# Appendix B

## **Analysis of Transportation Effects**

**Subject: DRAFT Analysis of Transportation Effects of Project Refinements to the Candlestick Point/Hunters Point Shipyard Phase II Project Since Certification of the Project's Final EIR (Addendum 7)**

Figure 1A

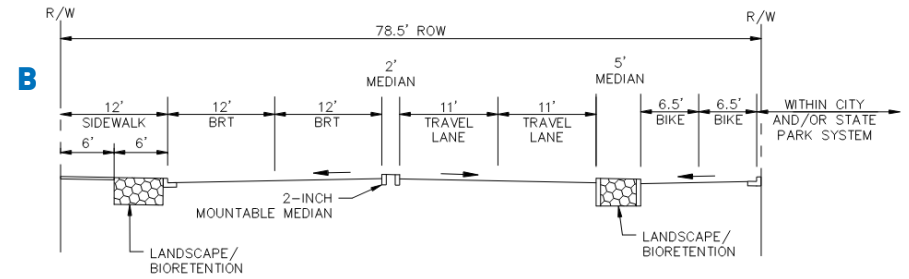
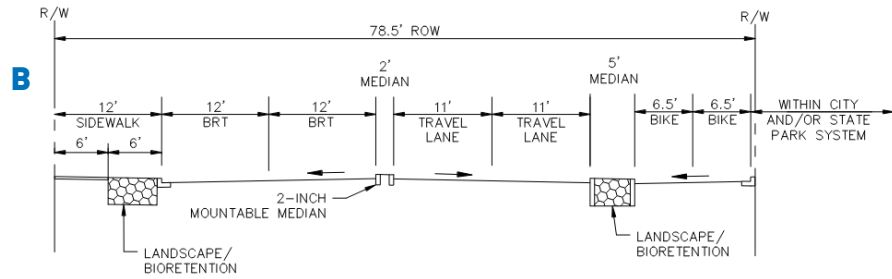
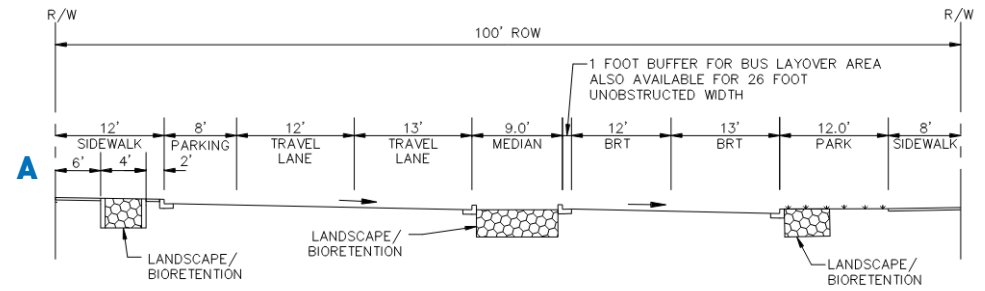
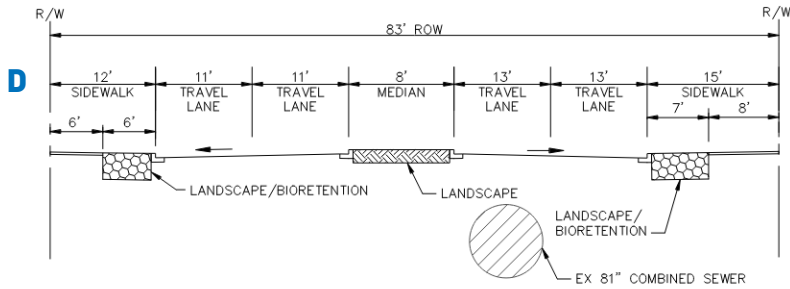
The 2024 Modified Project Variant also includes alternative cross-sections in the event certain privately owned properties (herein referred to as NAPOTS) are not acquired by the Project Sponsor or City. The NAPOTS properties are comprised of ten privately-owned parcels and three public rights-of-way for proposed streets included in the Project. The NAPOTS properties are approximately bounded by Arelious Walker to the west, Egbert Avenue to the north, West Harney Way to the east, and Gilman Avenue to the south. **Figures 1A and 1B** illustrates the location of the cross-section, the existing proposed cross-section with acquiring NAPOTs, and the alternative cross-sections without acquiring NAPOTS. The 2010 FEIR assumes acquisition of the NAPOTS properties and the three public rights-of-way by the Developer or City, which would be reconfigured into development blocks and new public rights-of-way. As shown, the West Harney Way, Egbert Avenue, and Gilman Avenue cross-sections remain consistent and require no modifications in the event the Developer or City do not acquire the NAPOTS. The Arelious Walker cross-section would require some modifications with removal of an 8 foot-wide median, and reduced sidewalks on the east side of the street. The lane configurations along Arelious Walker would remain as proposed and would not alter the capacity of the roadway.

Figure 1B

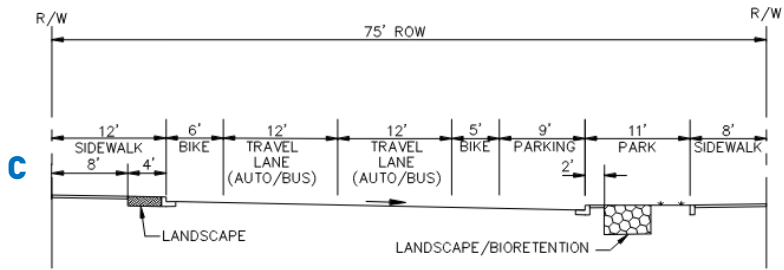
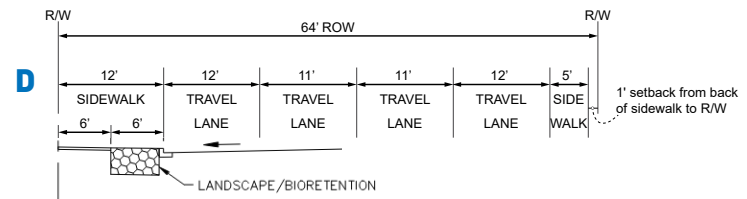
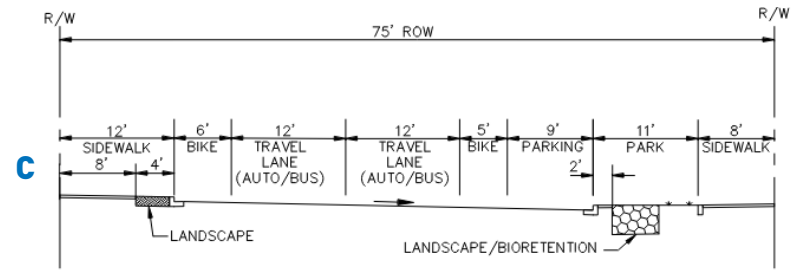
Modified Project Variant.<sup>1</sup> The 2024 Modified Project Variant does not propose any additional modifications than those identified in the 2019 Modified Project Variant with exception to the cross-section alternatives required in the event that the NAPOTS parcels are not acquired by the Project Sponsor or City. As described above and illustrated in Figures 1A and 1B the West Harney Way, Egbert Avenue, and Gilman Avenue cross-sections remain consistent and require no modifications in the event the Project Sponsor or City does not acquire the NAPOTS. The Arelious Walker cross-section would require some modifications with removal of 8 foot-wide median, and reduced sidewalks on the east side of the street. The lane configurations along the remainder of Arelious Walker would remain as proposed and would not alter the capacity of the roadway.

Figure 9: Candlestick Point Transit Demand vs Proposed Capacity (PM Peak Hour)

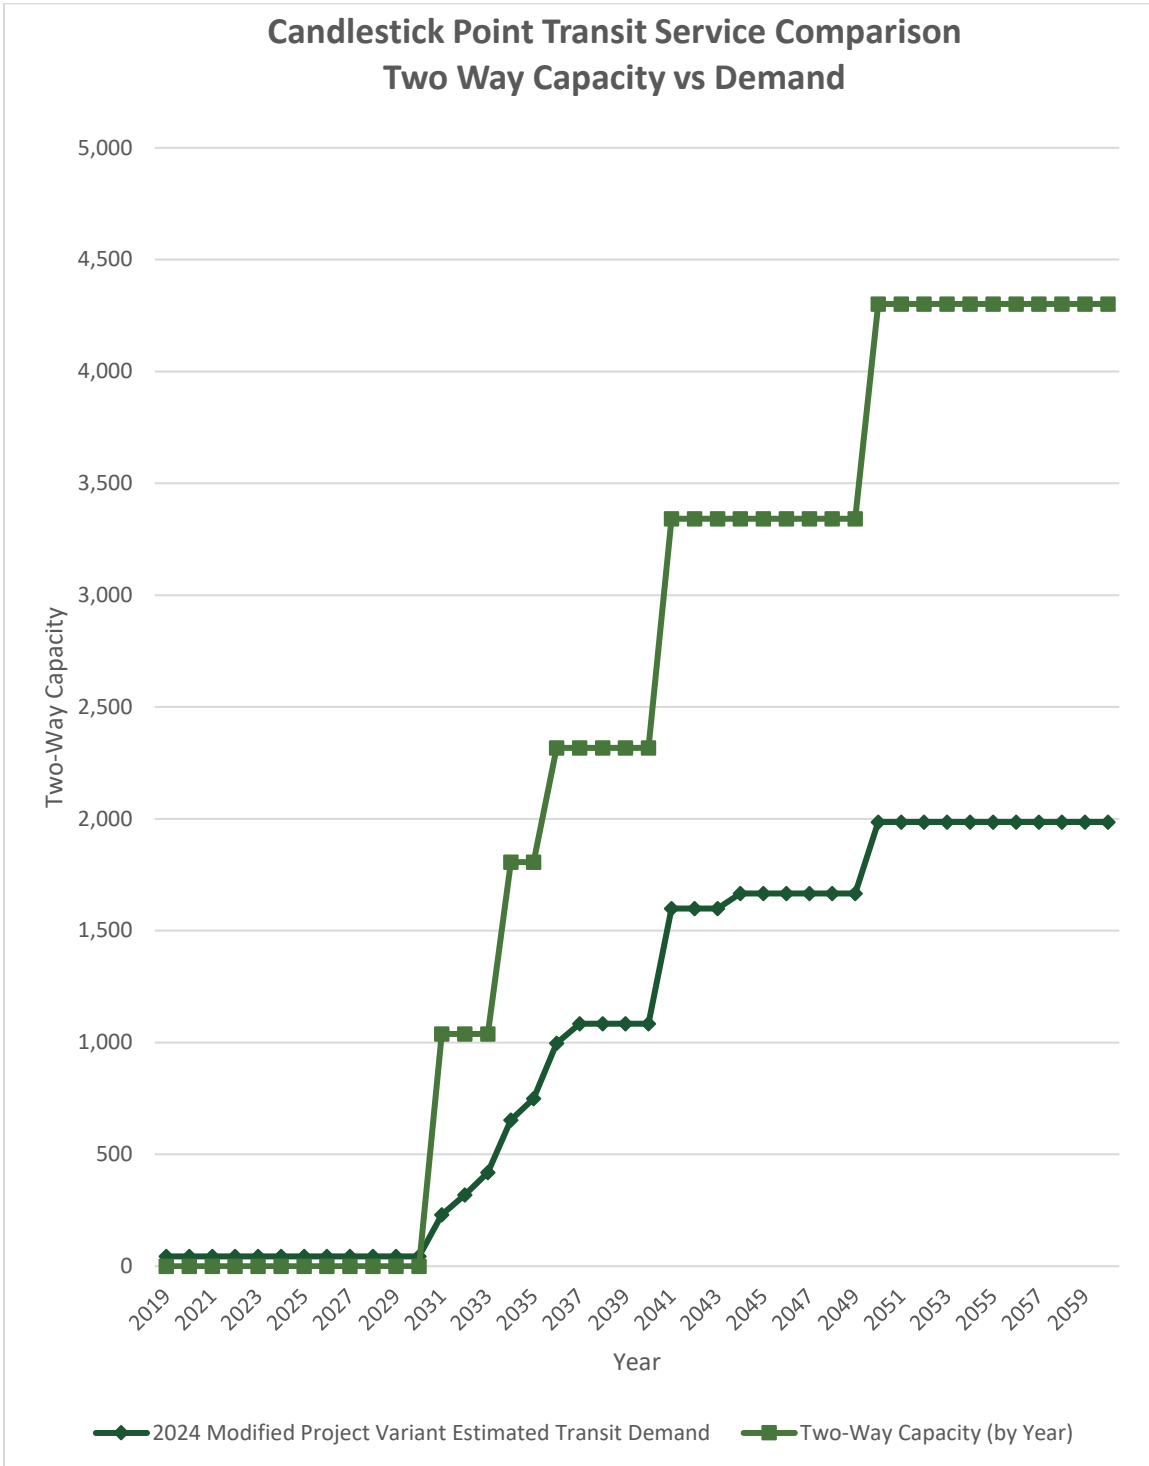
**Figure 9** summarizes the level of transit supply proposed to be implemented over time relative to the expected transit ridership demand, based on the development phasing schedule and the transit implementation triggers described above, for CP. As shown in Figure 9, the level of transit service relative to demand will always remain substantially higher than the demand at CP.
